Item: 245kV CT

Ratio: 200/1A, 1C

Customer: APTransco, Andhra Pradesh

List of Standard Drawings/Documents:

TITLE : GENERAL ARRANGEMENT
245KV CT
APTR-04.31.245J1
SHEET 1 OF 1 | REV. NO. : 00

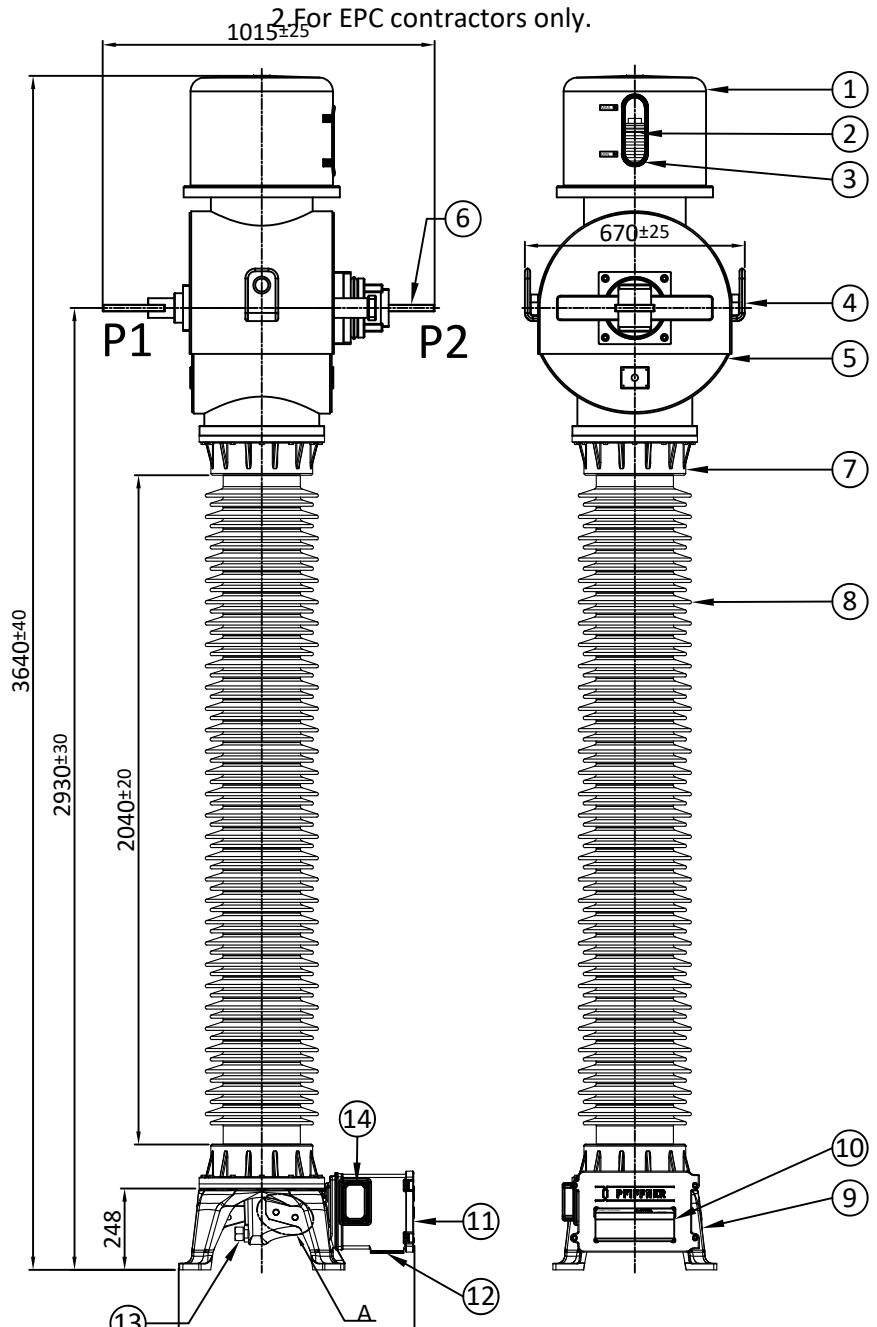
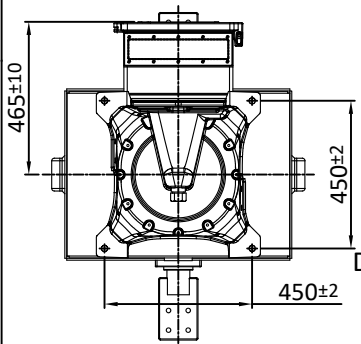
1. Minimum 300mm plinth shall be maintained for CT/PT/CVT/ Isolators/IVT in the substation during foundation works to ensure safe live to ground clearance as per IE rules.
2. Since the supply of terminal connectors is not in the scope of manufacturers as mentioned in the drawings. The EPC contractors shall be instructed to supply the same in line with CT/PT/CVT/Isolator /IVTs requirement and capatibility.

Variation of Tan Delta Value from 10KV um/sqrt 3 shall be not exceed 15%.

NOTE:-1. Drawings approval subject to valid type test reports, to be checked during acceptance tests.
2. For EPC contractors only.

REV.NO.	DESCRIPTION	APPV'D	REV. DATE
01			
GEN. TOL : NA		MATERIAL : NA	
WEIGHT : NA		SPEC : NA	
DRAWN	DHM	18.04.2023	FINISH : NA
CHK'D	CHM	18.04.2023	
APPV'D	CHM	18.04.2023	
TITLE : TERMINAL BOX GA 245KV CT		SCALE : N.T.S.	
DWG NO.		SHEET SIZE : A3	
SHEET 1 OF 1		REV. NO. : 00

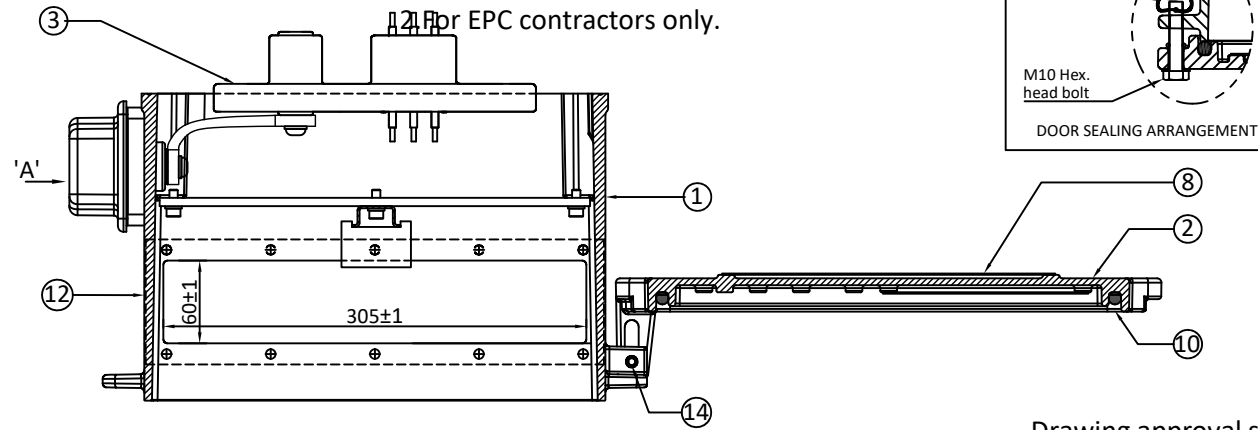
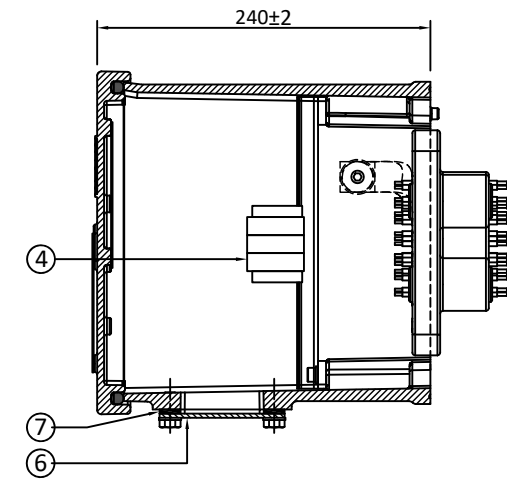
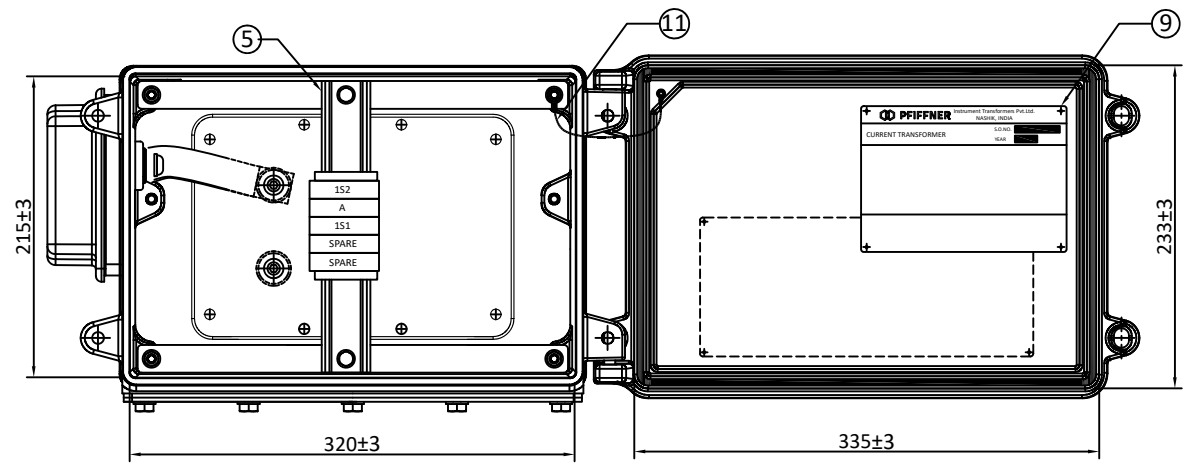
NOTE:-1. Drawings approval subject to valid type test reports, to be checked during acceptance tests.

2. For EPC contractors only.

Variation of Tan Delta Value from 10KV um/sqrt 3 shall be not exceed 15%.

APTR-04.31.245J4

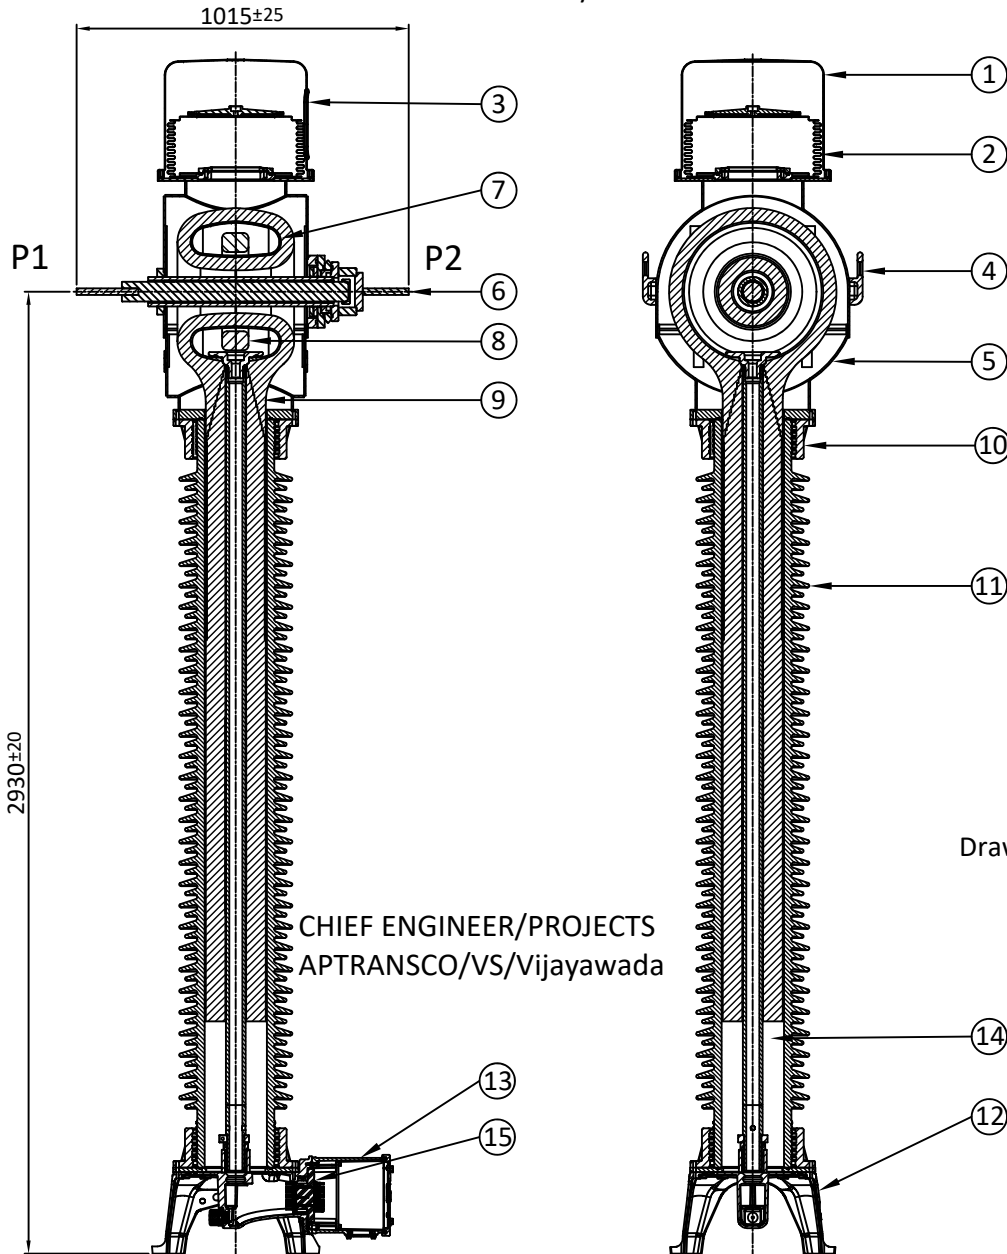
NOTE:-1. Drawings approval subject to valid type test reports, to be checked during acceptance tests.
2. For EPC contractors only.

Variation of Tan Delta Value from 10KV um/sqrt 3 shall be not exceed 15%.
